TECHNICAL SERVICE BULLETIN

Technical Service Bulletin: 203-1611

Forest River is alerting you to an issue involving certain 2023 Catalina - BCAT184BHS travel trailer recreational vehicles. Please see the information below which describes the issue and provides you with details on the steps you should take to have your vehicle repaired. Please note – this Technical Service Bulletin expires after one year from the month on this letter.

Certain vehicles may be missing sealant in the slide-room columns.

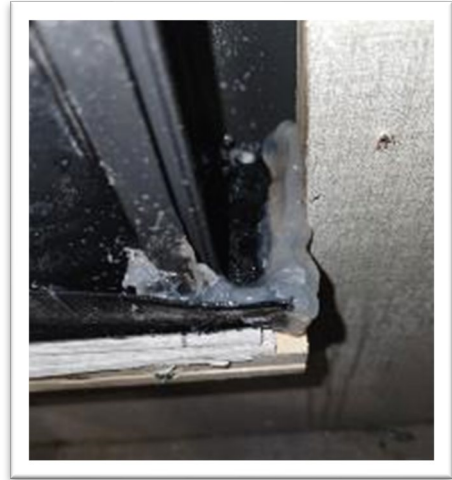
1. Run slide out in halfway. Remove left side fascia and black board.	
2. Remove both Jam clamps on both sides of box.	
3. Apply seal to the top inside of mech near the motor. Both sides (see pictures).

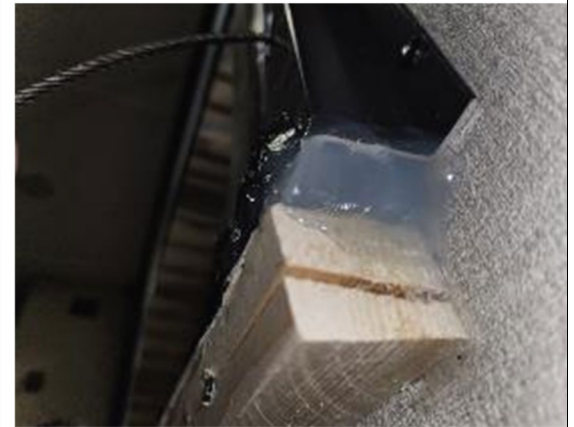
4. Apply seal to the bottom of the mech between the mech and sidewall to create an "L" shape (see pictures). It is important not to get this on the front of the mech facing the outside. This is so water can drain out.

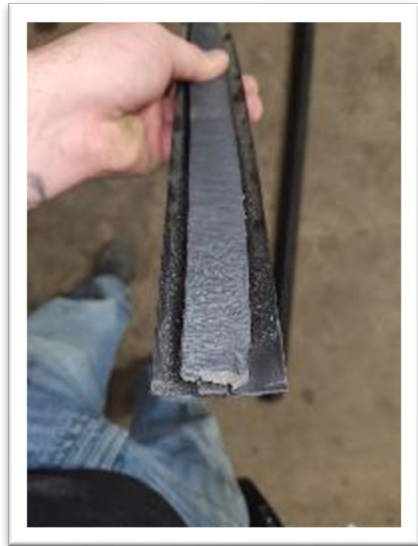
1. Remove top and bottom rails on side of slide out. Add 3/4" putty to those rails where screws are to be placed.

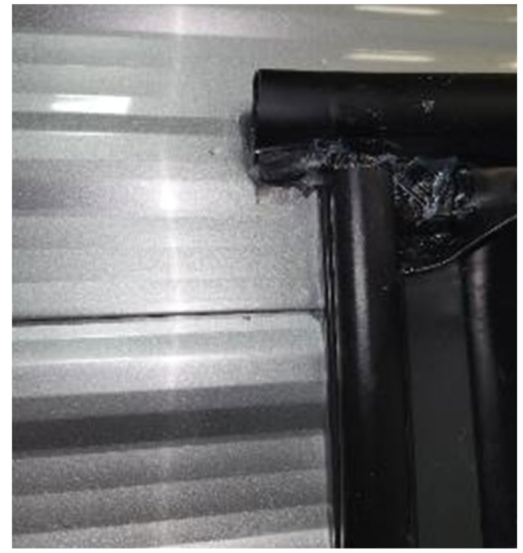
5. Replace top bulb seal with 794 from Boyd Industries. Extend the bulb seal 1" passed the slide out opening. (see pictures)
